Number: 737-26-1138
Original Issue: December 12, 2014
ATA System: 2614

SUBJECT: FIRE PROTECTION - Lavatory Smoke Detection System - Replacement of JAMCO
Lavatory Smoke Detectors

BOEING SERVICE BULLETIN 737-26-1138

**FIGURE 1: PASSENGER CABIN LAVATORY SMOKE DETECTOR REMOVAL
(SHEET 1 OF 3)**

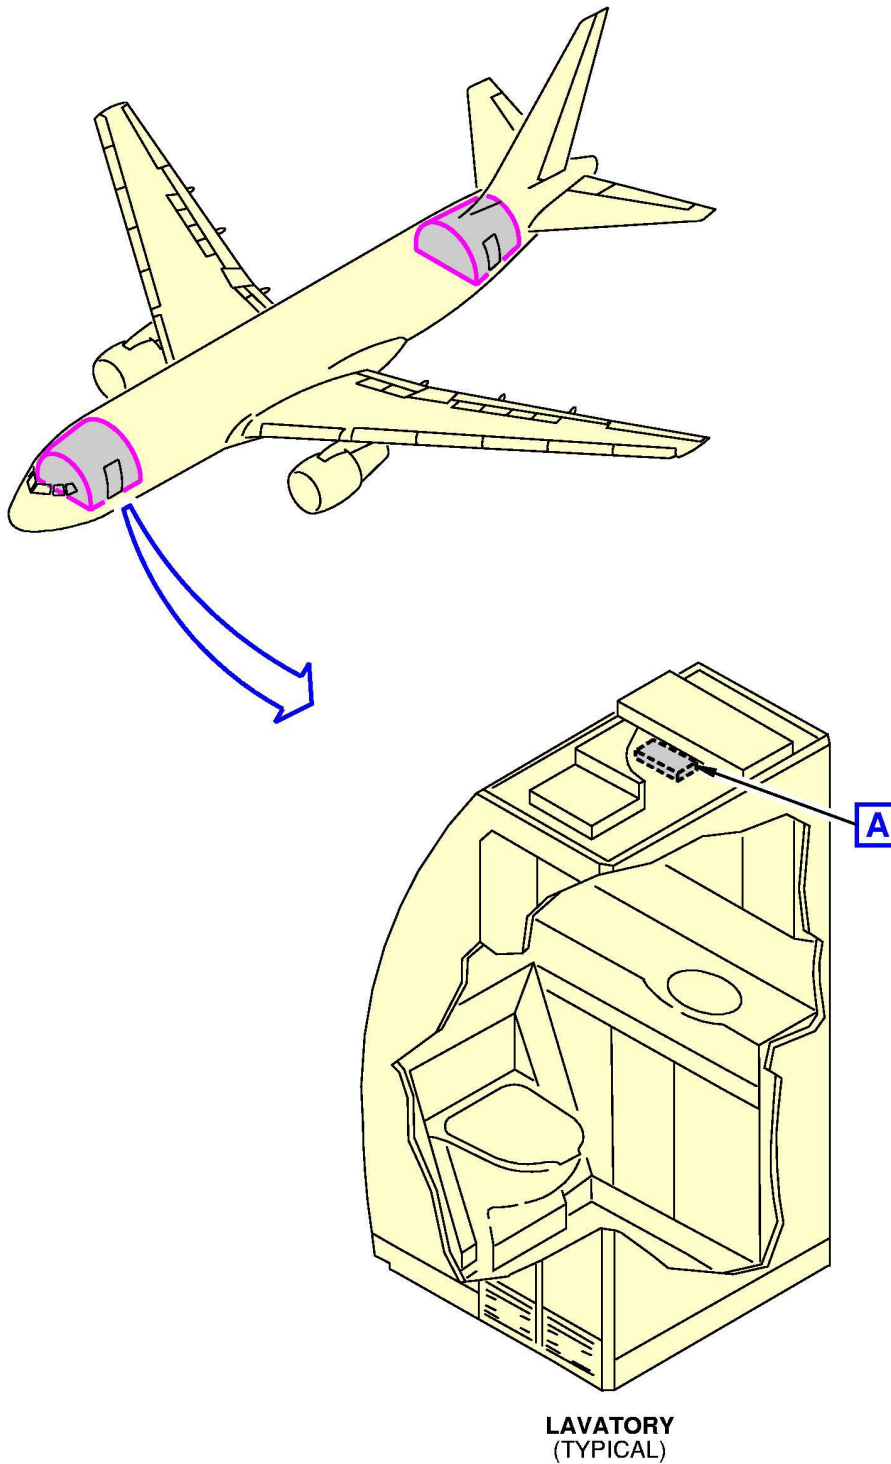
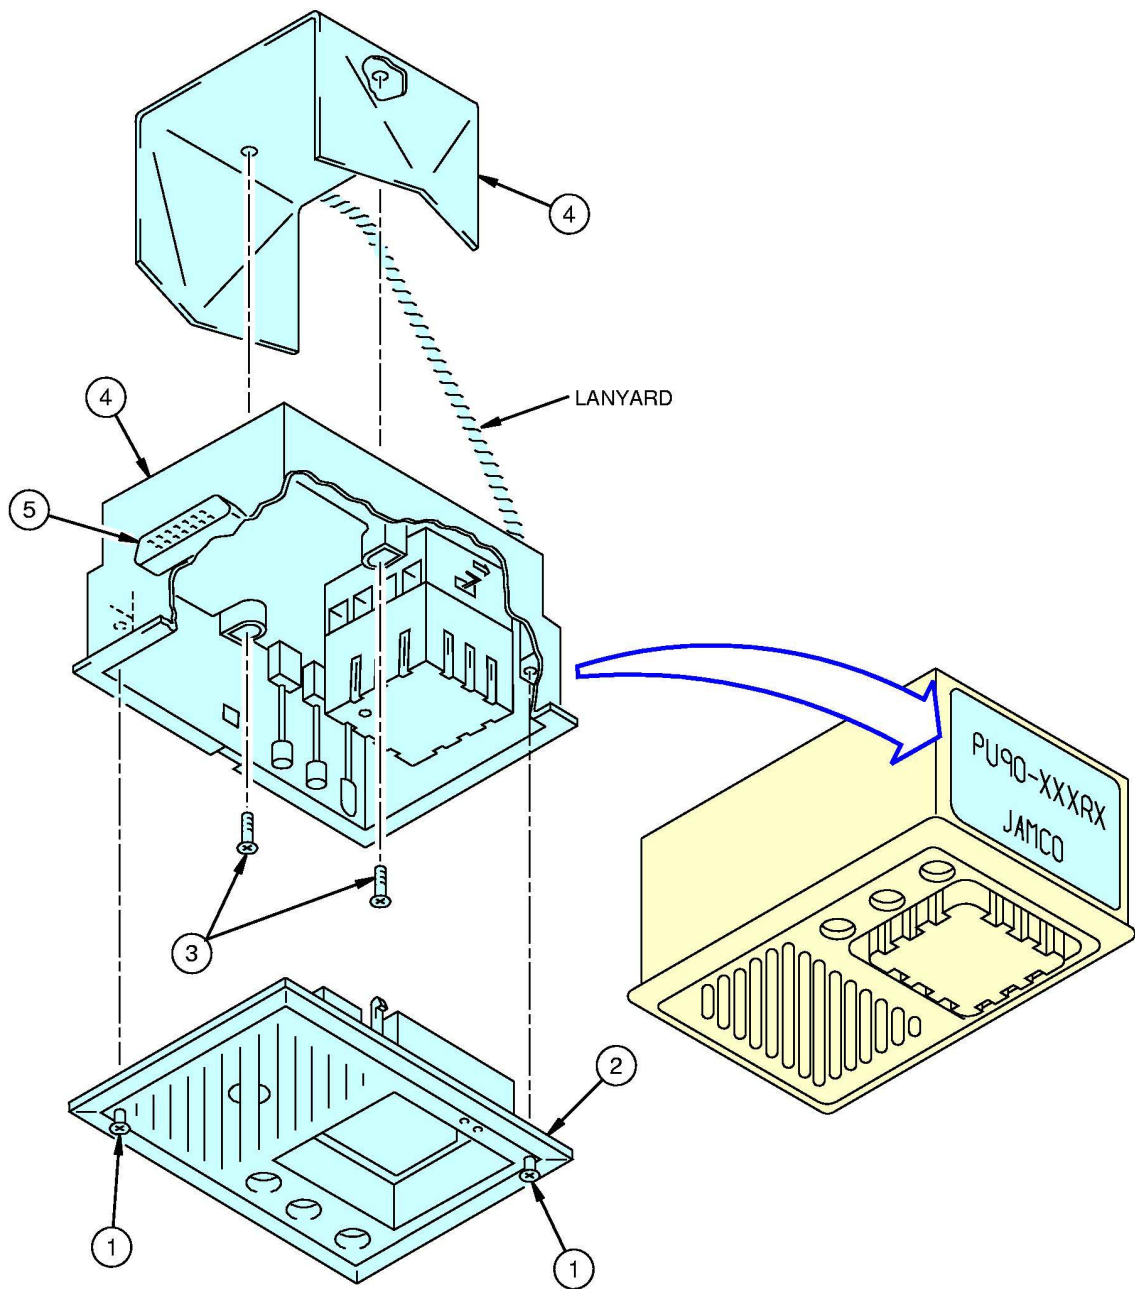
1. Open the PASS & CREW CALL/LAV SMOKE DETECTOR Circuit Breaker on P18-4 Panel and install safety tags.
2. Get access to the lavatory.
3. Remove smoke detector and the ceiling bracket in accordance with FIGURE 1.
4. Identify the part number of the removed smoke detector.

Step	Task	Name	Identification	Qty	More Data
1	Loosen	Screws	-	2	(a)
2	Remove	Smoke Detector Faceplate	-	1	
3	Remove	Screws	-	2	
4	Remove	Smoke Detector	PU90-XXXRX	1	(b)
	Remove	Ceiling Bracket	-	1	
5	Disconnect	Electrical Connector	-	1	
(a) The screws are attached to the faceplate and cannot be removed.					
(b) Where PU90-XXXRX is one of the part numbers that follow: PU90-499R4, PU90-499R3, PU90-461R4, PU90-461R3, or PU90-431R3.

**FIGURE 2: PASSENGER CABIN LAVATORY SMOKE DETECTOR INSTALLATION
(SHEET 1 OF 2)**

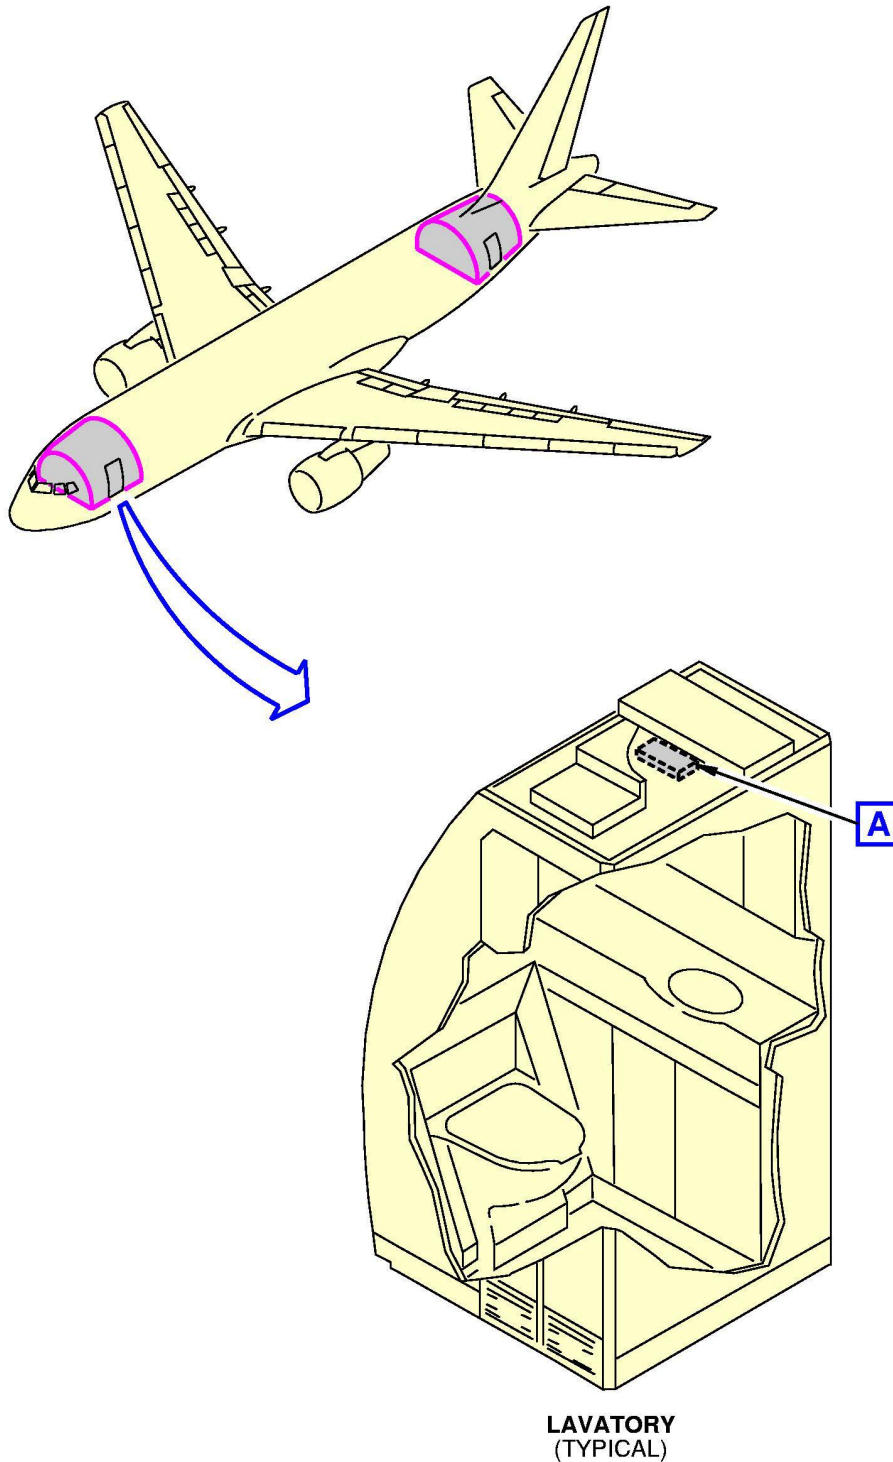
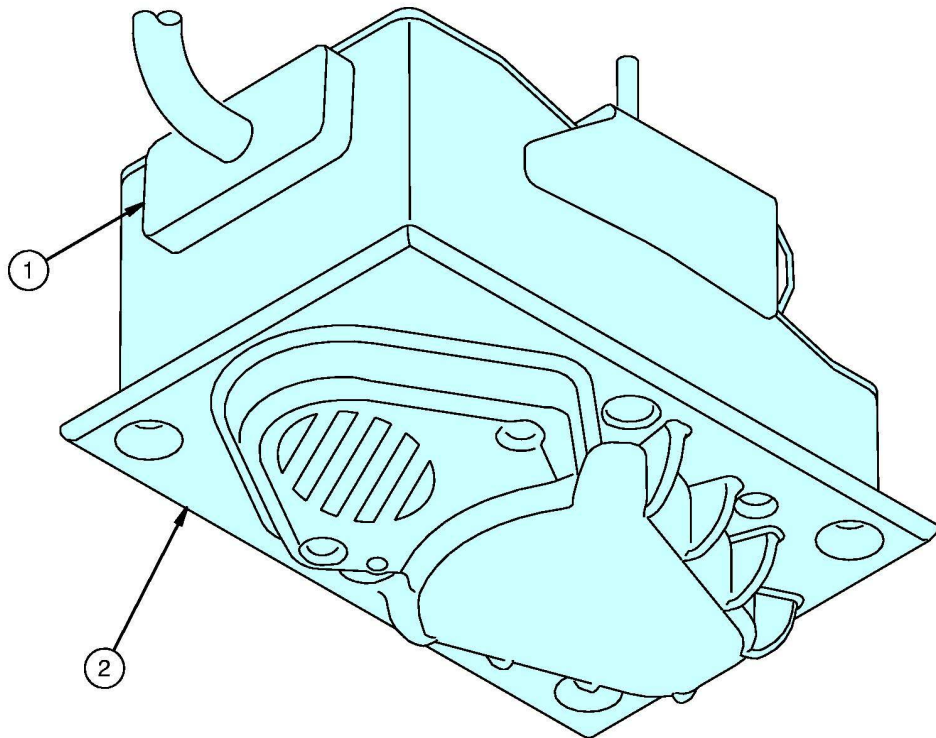
2. Install new smoke detector in accordance with FIGURE 2.
3. Close the PASS & CREW CALL/LAV SMOKE DETECTOR Circuit Breaker on P18-4 Panel and remove safety tags.

Step	Task	Name	Identification	Qty	More Data
1	Connect	ELECTRICAL CON- NECTOR	-	1	
2	Install (New)	SMOKE DETECTOR, M3000 DISCRETE PHOTOELECTRIC	475571-2	1	(a) (b) (c)
(a) Put the smoke detector in the correct position in the lavatory ceiling.					
(b) Push the mounting screws until the ceiling bracket is in the correct position.					
(c) Tighten fasteners to 9-10 in/lbs.

**FIGURE 3: PASSENGER CABIN LAVATORY SMOKE DETECTOR INSTALLATION
(SHEET 1 OF 2)**

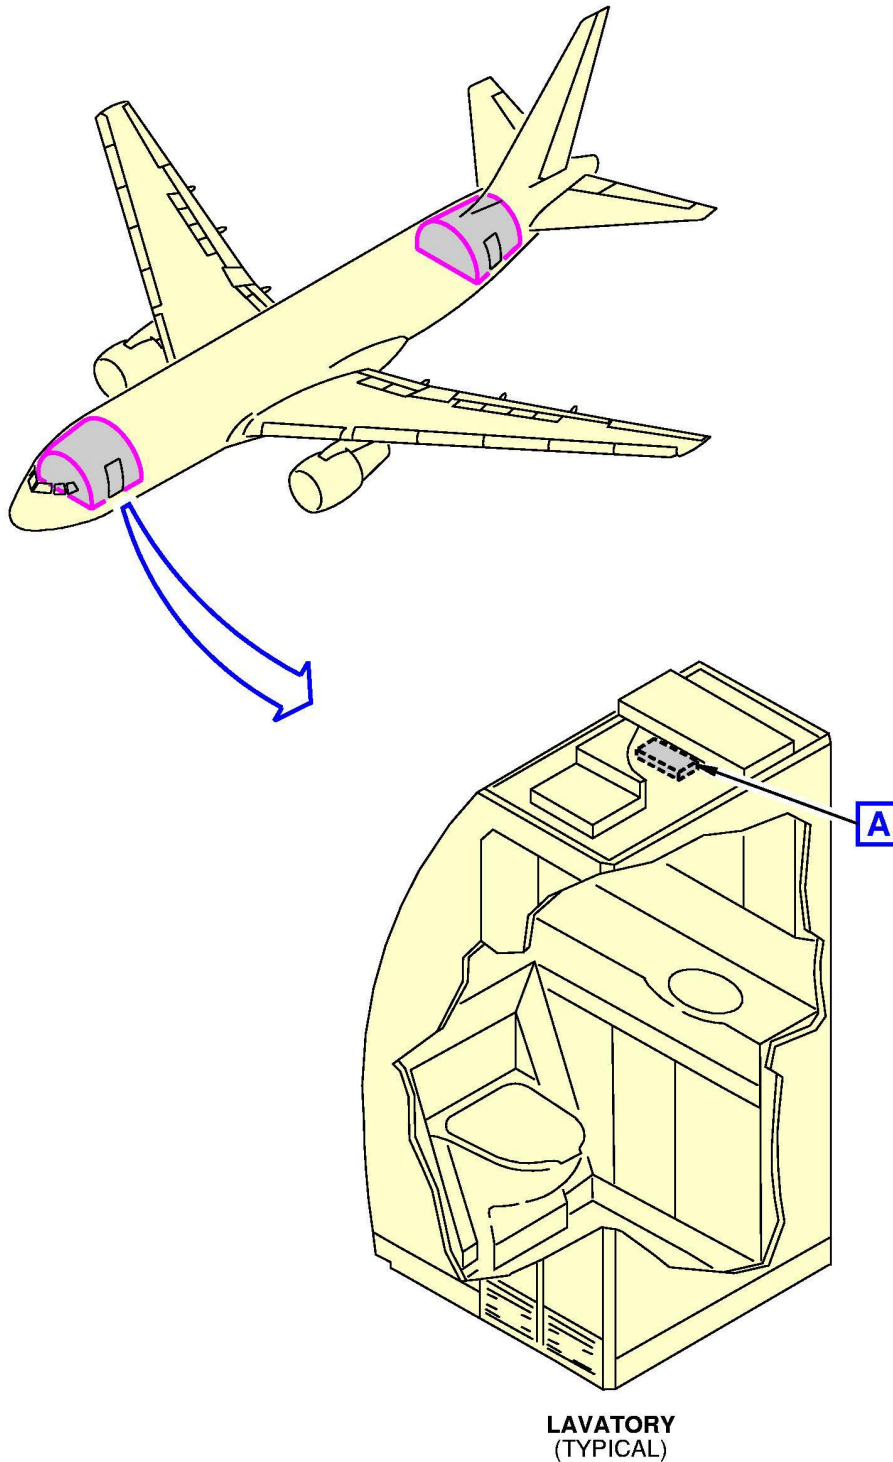
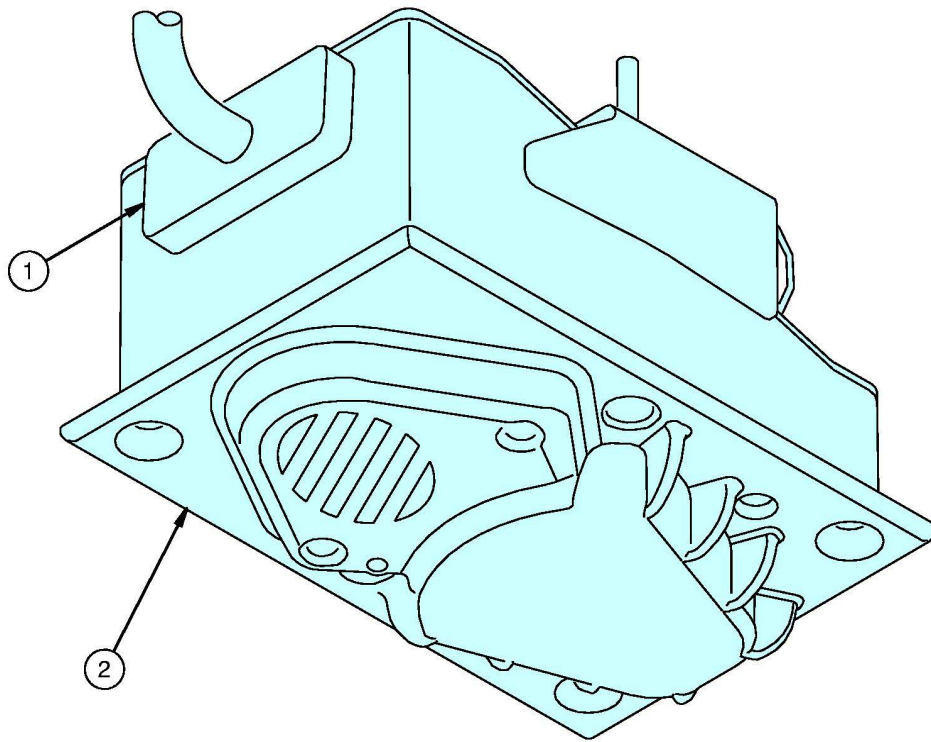
2. Install new smoke detector in accordance with FIGURE 3.
3. Close the PASS & CREW CALL/LAV SMOKE DETECTOR Circuit Breaker on P18-4 Panel and remove safety tags.
4. Do the Lavatory Smoke Detection - Self Test in accordance with the instructions that follow:
 - a. Supply electrical power to the airplane. Refer to 737-100/200 AMM 24-22-00 or 737-300/400/500 AMM 24-22-00 as an accepted procedure.

Step	Task	Name	Identification	Qty	More Data
1	Connect	ELECTRICAL CON- NECTOR	-	1	
2	Install (New)	SMOKE DETECTOR, M3000 DISCRETE PHOTOELECTRIC	475571-3	1	(a) (b) (c)
(a) Put the smoke detector in the correct position in the lavatory ceiling.					
(b) Push the mounting screws until the ceiling bracket is in the correct position.					
(c) Tighten fasteners to 9-10 in/lbs.
